Interdisciplinary Environmental Clinic

Re: 2015 Monitoring Network Plan

Re: Comments on Ameren Missouri's Labadie Sulfur Reduction Project Quality Assurance Project Plan

Re: Comments on Ameren Missouri's Analysis of SO₂ and Meteorological Monitoring Stations Around Its Rush Island Energy Center

Figure 1. Modeled SO₂ design values in the vicinity of the Rush Island Energy Center.

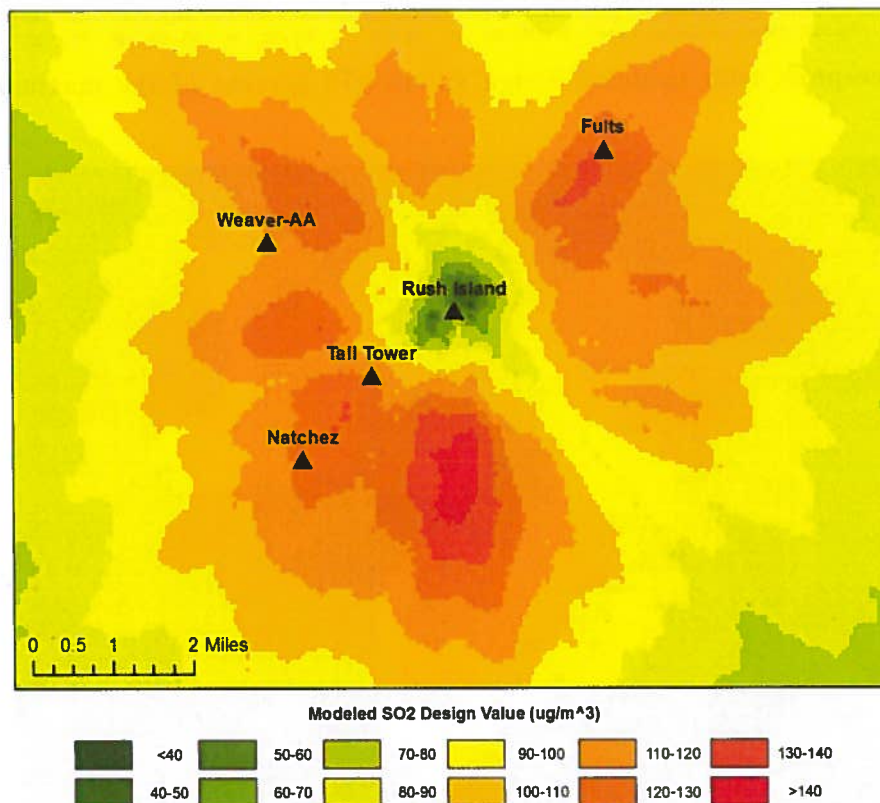
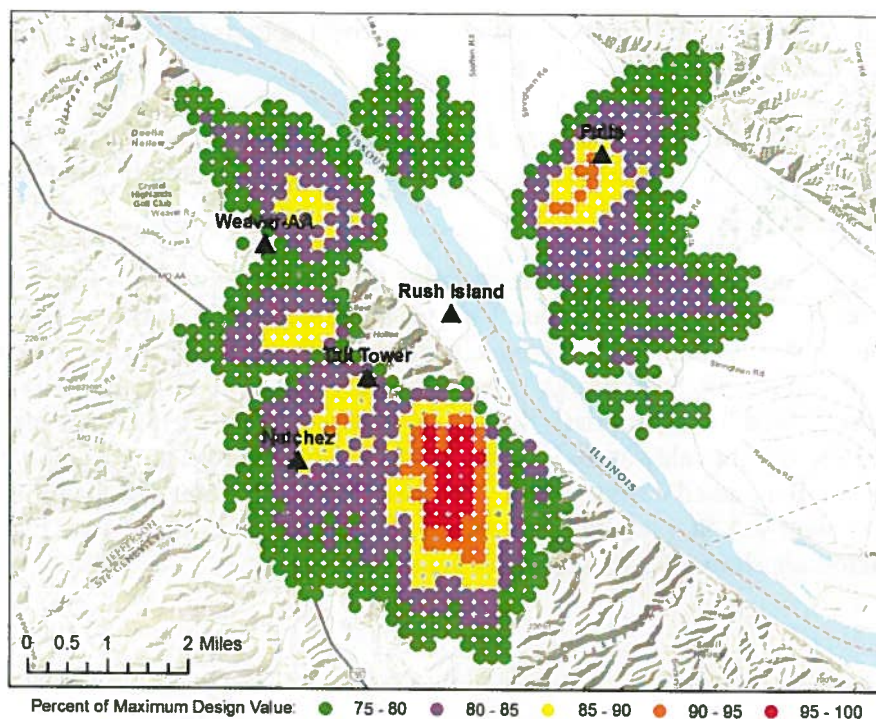
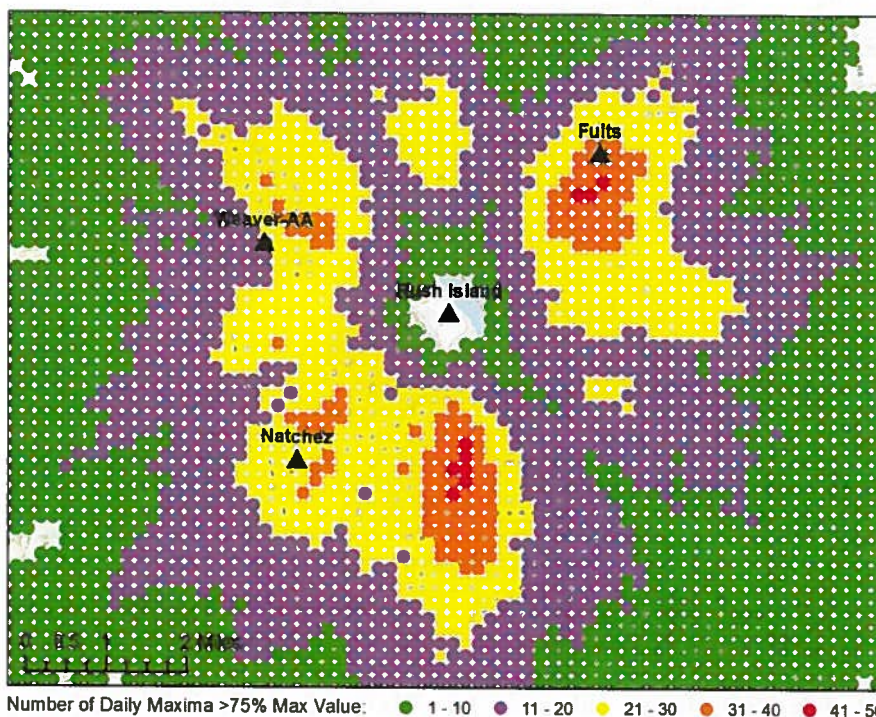
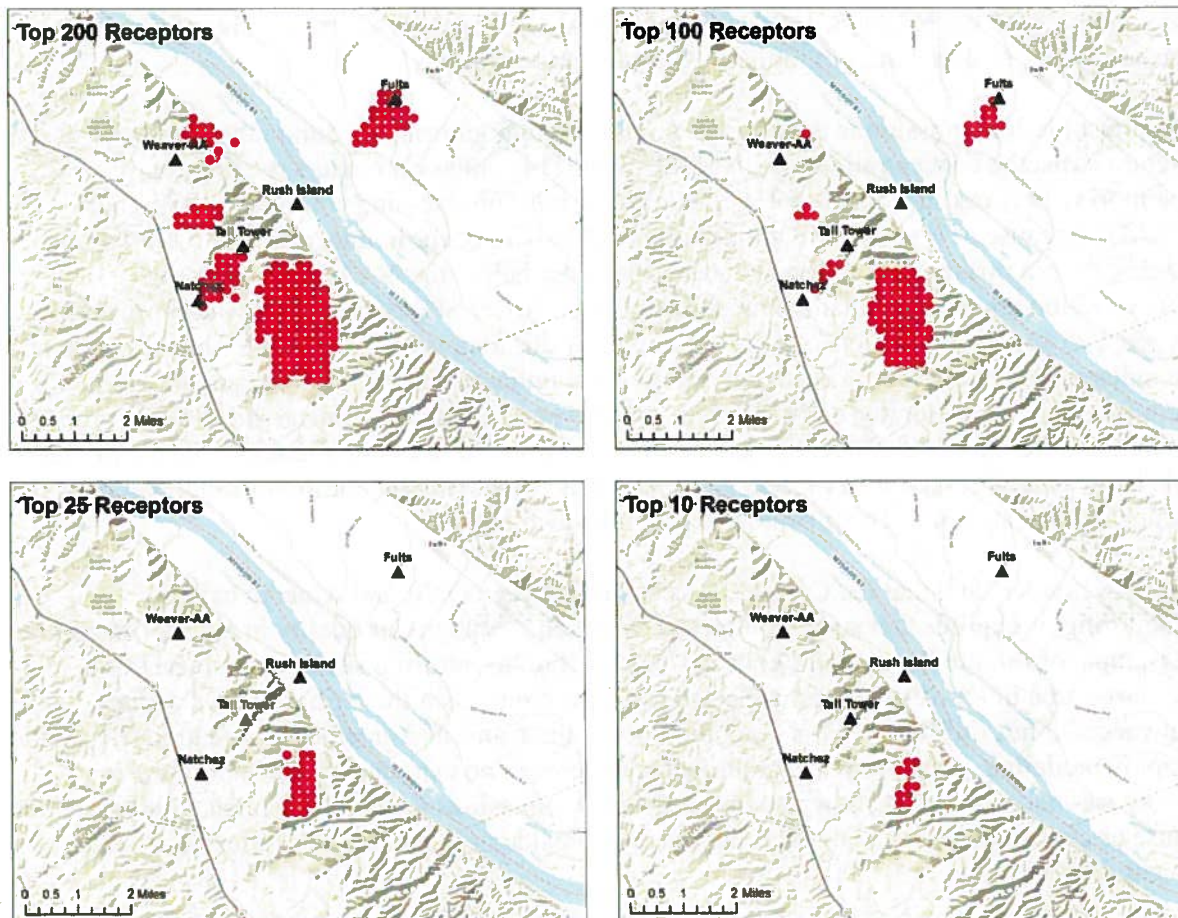
Figures 1 through 4 all reveal a strikingly similar pattern regarding the areas where peak 1-hour SO_2 concentrations are expected to occur around the Rush Island Energy Center. There is a large area due south of the plant where modeled design values are the highest (in excess of 95 percent of the maximum modeled design value), where modeled maximum daily 1-hour concentrations frequently exceeded 75 percent of the maximum modeled design value, and where over half of the top 200 receptors (including all of the top 25 and three quarters of the top 100) are located. There are also four other areas where modeled design values are slightly lower but still very high (in excess of 85 percent of the maximum modeled design value), where modeled maximum daily 1-hour concentrations frequently exceeded 75 percent of the maximum modeled design value, and where the rest of the top 200 receptors are located. These four areas, located northeast, northwest, west, and southwest of the plant, plus the area south of the plant where modeled design values are the highest, are where Ameren's modeling predicts peak 1-hour SO_2 concentrations are expected to occur. Monitoring stations located in these areas would have the greatest chance of identifying peak SO_2 concentrations in ambient air, which is the primary objective of source-oriented monitoring and an absolute necessity when monitoring to assess

compliance with the NAAQS. However, none of Ameren's proposed monitoring stations is located in any of these areas of highest expected concentrations.

The most glaring omission is that there is no proposed monitoring station in the large area of highest expected concentrations south of the plant. This omission renders the proposed monitoring network inadequate for its intended purpose of assessing compliance with the NAAQS because a) NAAQS violations are most likely to occur in this area, and b) violations could occur in this area even when concentrations are below the NAAQS in other high concentration areas, given that the modeling predicts lower SO₂ concentrations in those areas. Ameren's Monitoring Stations Analysis claims that this area is "not accessible" because it hosts an industrial plant (Holcim). The Analysis does not indicate whether Ameren sought Holcim's permission to site a monitor on the Holcim property, and does not delineate the Holcim property boundary in terms of the modeling results. In other words, it does not document the claim that this large area of maximum expected concentrations is inaccessible for monitoring. Nor does it evaluate the nearest non-Holcim site that might be available.

Figure 5. Modeled design values, receptors with design values ≥ 75 percent of the maximum modeled design value, and proposed monitoring station locations.

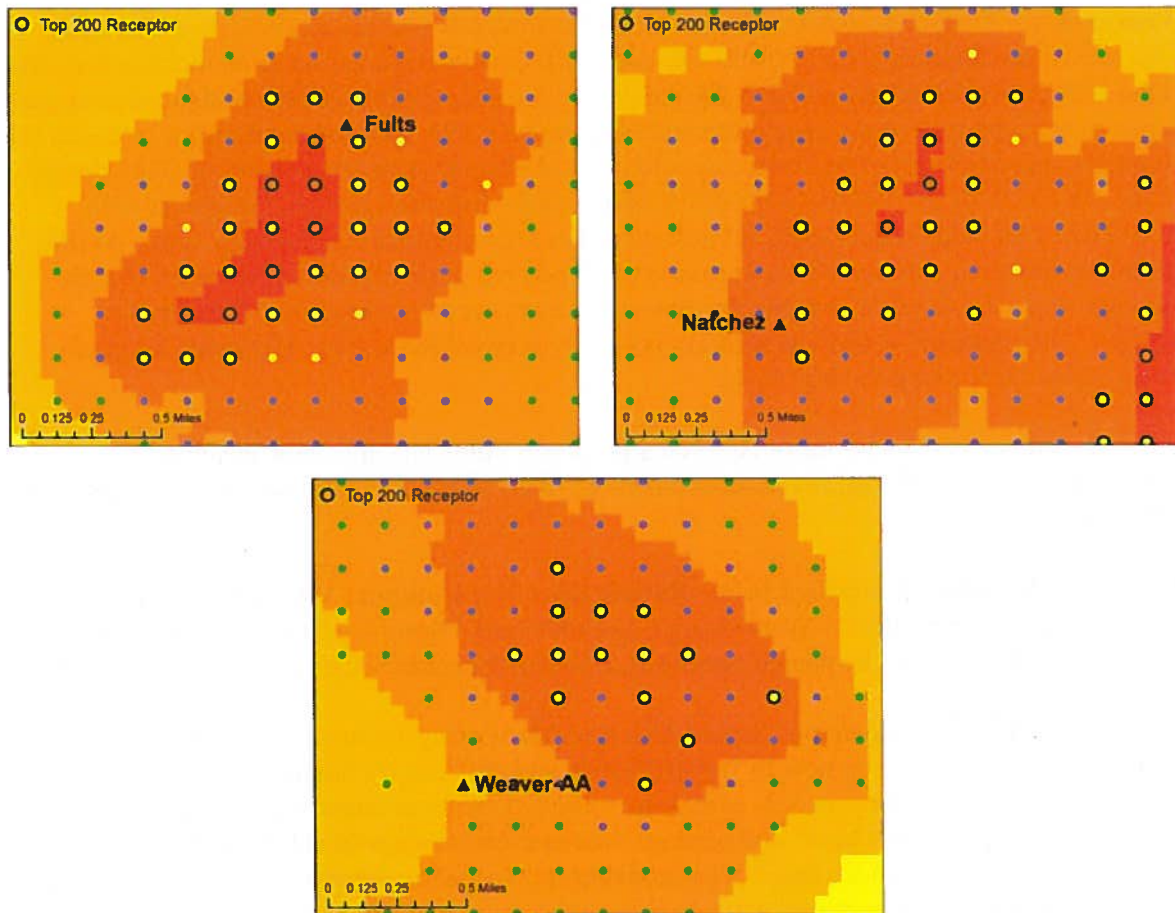
Furthermore, two of the proposed monitoring stations – Fults and Natchez – are located near but outside of areas of modeled peak concentration/high frequency instead of near the center of such areas, where concentrations are expected to be higher. The third proposed station – Weaver-AA – is located entirely outside of modeled peak concentration/high frequency areas. Figure 5 shows the locations of the proposed monitoring stations on a hybrid basemap comprised of Figures 1 (modeled design values) and 2 (receptors with modeled design values ≥ 75 percent of the maximum design value). Receptors that are among the 200 with the highest modeled design values are outlined for reference. All three monitoring stations could easily be sited in areas where higher 1-hour SO₂ concentrations are expected to occur with greater frequency, thereby increasing their chances of detecting any NAAQS exceedances that might occur around the Rush Island Energy Center. As discussed below, we urge DNR to consider these proposed optimized locations in lieu of Ameren's proposed Fults, Natchez, and Weaver-AA locations.

Fults – Of the three proposed monitoring stations, the Fults monitoring station is closest to an area where peak 1-hour SO₂ concentrations are expected to occur. However, moving the monitor less than one kilometer southwest of its current location would move it from an area with modeled design values in the 120-130 ug/m³ range to an area with modeled design values in the 130-140 ug/m³ range and place it near the center of a small group of receptors with modeled design values equal to 90-95 percent of the maximum modeled design value (the receptors

surrounding its current location generally have modeled design values equal to 85-90 percent of the maximum modeled design value). The entire area is floodplain/agricultural and Ivy Road, oriented northeast-southwest, runs through the middle of it, making the proposed optimized location as accessible as Ameren's proposed location and equally easy to provide power to.

Natchez – The Natchez monitoring station is outside/on the outer edge of an area where peak 1-hour SO_2 concentrations are expected to occur. Moving it approximately one kilometer northeast of its current location would move it from an area with modeled design values in the $120\text{-}130\text{ ug/m}^3$ range to an area with modeled design values in the $130\text{-}140\text{ ug/m}^3$ range, and place it between a pair of receptors with modeled design values equal to 90-95 percent of the maximum modeled design value (the receptors surrounding its current location have modeled design values equal to 80-90 percent of the maximum modeled design value). It would also move it to an area where higher concentrations are expected to occur with slightly greater frequency. The proposed optimized location is accessible via transmission right of way, and power is available along Dubois Creek Road to the south-southwest.

Weaver-AA – The Weaver-AA station is located completely outside of all areas where peak 1-hour SO₂ concentrations are expected to occur. Modeled design values at its location are only in the 100-110 ug/m³ range, and it is surrounded by receptors with modeled design values equal to just over 75 percent of the maximum modeled design value. Moving the monitor just over one kilometer east-northeast of its current location would place it in an area where modeled design values are 15-20 ug/m³ higher, in the midst of a slightly dispersed group of receptors with modeled design values equal to 85-90 percent of the maximum modeled design value. At this optimized location, concentrations in excess of 75 percent of the maximum modeled design value are expected to occur roughly twice as often as at Ameren's proposed Weaver-AA location. The proposed optimized location is readily accessible via State Highway AA, and power is available along the highway.

Figure 6. Current and optimized locations of the Fults, Natchez, and Weaver-AA monitoring stations

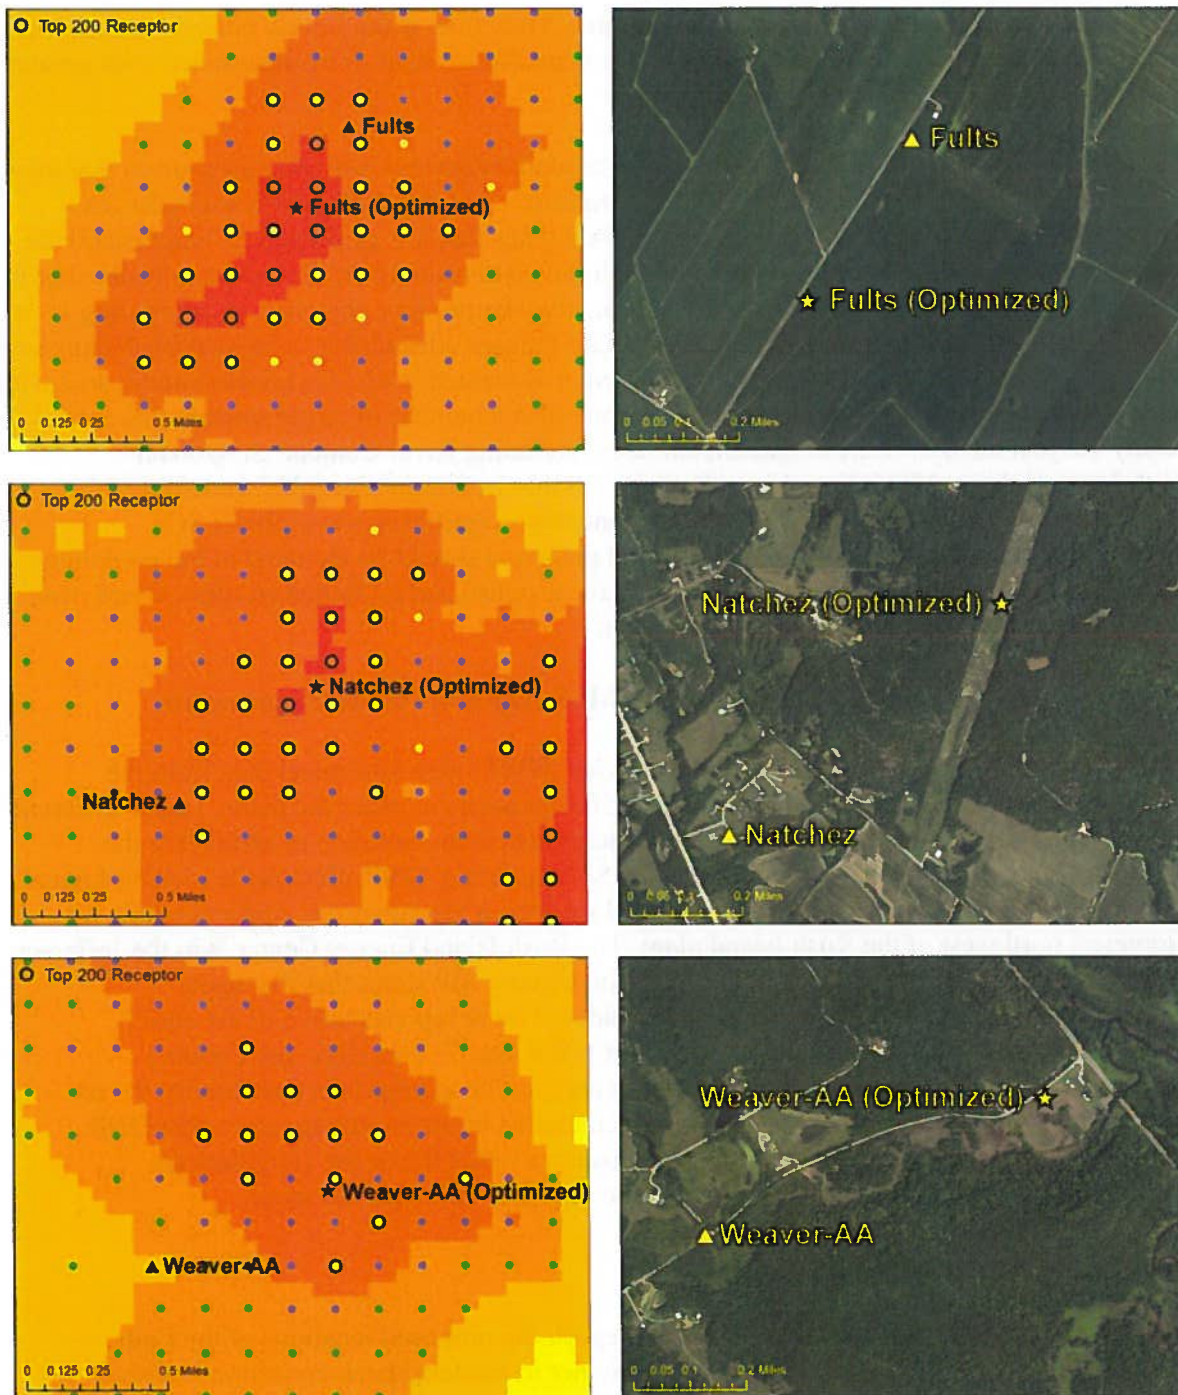
Figure 6 compares the locations of Ameren's proposed Fults, Natchez, and Weaver-AA monitoring stations with optimized locations more likely to record maximum SO₂ concentrations in the area.

We urge DNR to reject the proposed monitoring sites and require Ameren to add a monitoring station in the highest concentration area due south of the plant as well as to relocate the proposed Fults, Natchez, and Weaver-AA monitoring stations to the optimized locations shown in Figure 5. We also urge DNR to require Ameren to 1) rerun the air dispersion model described in the report using Rush Island's actual hourly emissions; 2) evaluate the effects of nearby interactive sources (including, at a minimum, River Cement, St. Gobain Containers, Holcim, Mississippi Lime, Dynegy's Baldwin Energy Complex, and Ameren's Meramec Energy Center) on modeled peak concentration/high frequency areas; and 3) evaluate the appropriateness of using meteorological data from the Cahokia, Illinois airport instead of Doe Run Herculaneum given DNR's determination that the latter is more representative of the modeled area.⁷ We further urge DNR to require any necessary adjustments to the proposed monitoring network based on the results of these analyses.
